DIVISION OF FISHERIES & WILDLIFE

RE: LIHI Certification of Dwight Project FERC #10675

Comments on LIHI re-certification:

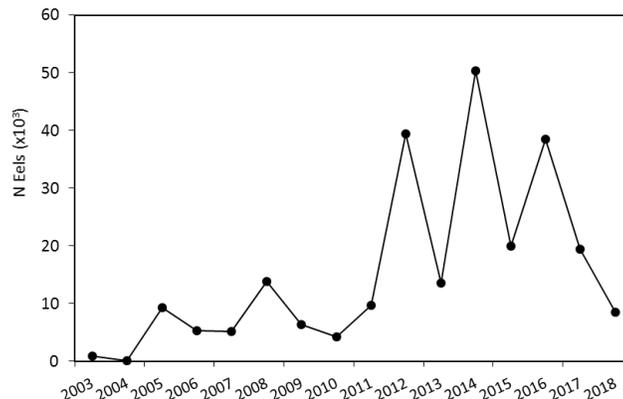
However, upstream passage for juvenile American Eel is relatively inexpensive and has proven to be very effective at many hydro projects in MA. In fact the Holyoke Project has passed hundreds of thousands of juvenile eels since passage was installed in 2003 (see figure below).

MassWildlife asks LIHI to make installation and testing of upstream passage for American Eel a condition of certification.
